3B Containment Hydrodynamic Loads

The information in this appendix of the reference ABWR DCD, including all subsections, tables, and figures, is incorporated by reference with the following departures.

STD DEP 3B-2 (Table 3B-1, Figures 3B-12 and 3B-13)

Figure 3B-12 Time History of Air Bubble Pressure

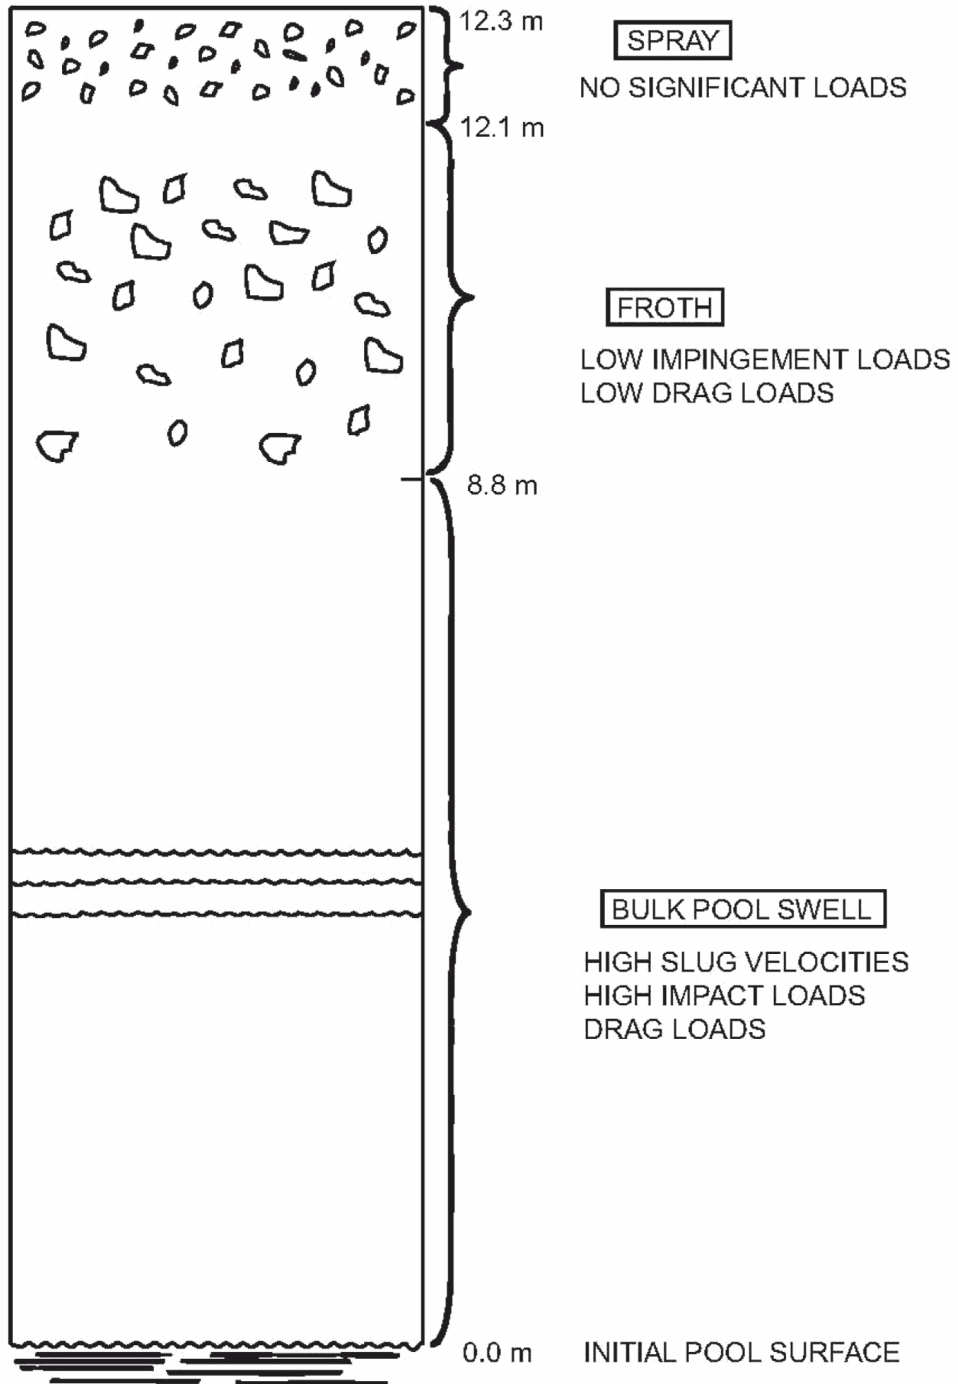
ABWR pool swell response calculations to quantify pool swell loads were based on a simplified, one dimensional analytical model. The model was qualified against test data from the Pressure Suppression Test Facility (PSTF) for a 1/3- scaled Mark III pressure suppression system geometry. The methodology is similar to, ~~same as that reviewed and accepted by the staff (NEDE-21544P/NUREG-0808) for application to Mark II plants. This analytical model was qualified against Mark II full scale test data.~~ The ABWR pressure suppression system design is similar to the Mark III design. The main difference is the smaller gas space above the suppression pool in the ABWR. This difference is accounted for in the analytical model for the pressure suppression system. ~~utilizes a confined wetwell airspace similar to that in Mark II design, but its vent system design is quite different than that in Mark II design. The ABWR vent system design utilizes horizontal vents similar to that in Mark III design. Therefore, recognizing this difference in vent system design, additional studies comparing model against Mark III horizontal vent test data were performed to assure adequacy of the model for application to ABWR.~~

Test data used to qualify the analytic model was taken from 1/3-scale tests for a Mark III geometry. The submergence to pool width ratio was representative of conditions in an ABWR. The GOTHIC code was used to model the Mark III tests. The model was designed to bound the test data. The test data used in the model comparison, and the modeling approach, are fully described in Reference 3B-17. ~~Model input/assumptions used in predicting Mark III test data for model comparison were the same as prescribed in NEDE 21544P. Mark III horizontal vent system features were modeled in the following manner:~~ The major modeling assumptions were:

Description	Value
1. Air bubble pressure (maximum)	133.37 kPaG 195 kPaG
2. Pool swell velocity (maximum)	10.9 m/s
3. Wetwell airspace pressur (maximum)	107.87 kPaG 146 kPaG
4. Pool swell height (maximum)	7m 8.8m

Figure 3B-13 Schematic of the Pool Swell Phenomenon

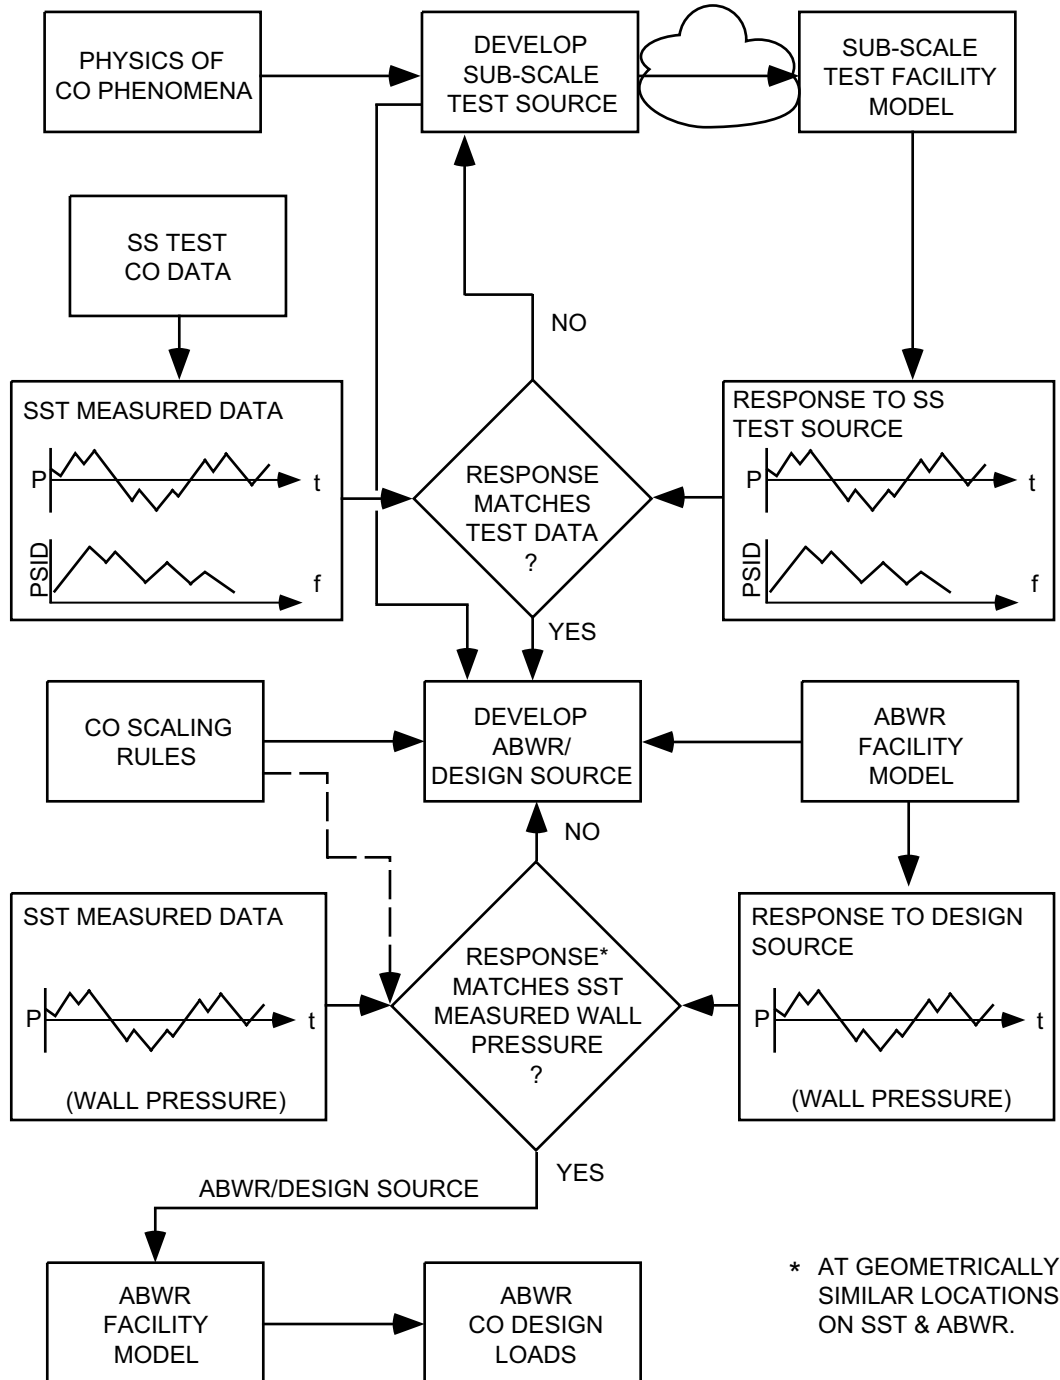
Structures located between 0 and ~~7m~~8.8m above the initial surface will be subjected to impact load by an intact water ligament, where the ~~7m~~8.8m value corresponds to the calculated maximum pool swell height. The load calculation methodology will be based on that approved for Mark II and Mark III containments (NUREG-0487 and NUREG-0978).

Structures located at elevations between the ~~7m~~8.8m and ~~40.3m~~12.1m will be subjected to froth impact loading. This is based on the assumption that bubble breakthrough (i.e., where the air bubbles penetrate the rising pool surface) occurs at ~~7m~~8.8m height, and the resulting froth swells to a height of 3.3m. ~~This froth swell height is the same as that defined for Mark III containment design and this.~~ This is considered to be conservative for the ABWR design. Because of substantially smaller wetwell gas space volume (about 1/5th of the Mark III design), the ABWR containment is expected to experience a froth swell height substantially lower than the Mark III design. The wetwell gas space is compressed by the rising liquid slug during pool swell, and the resulting increase in the wetwell gas space pressure will decelerate the liquid slug before the bubble break-through process begins. The load calculation methodology will be based on that approved for the Mark III containment (NUREG-0978).

As shown in Figure 3B-13 the gas space above the ~~40.3 m~~12.1m elevation will be exposed to spray condition ~~including~~ which is expected to induce no significant loads on structures in that region.
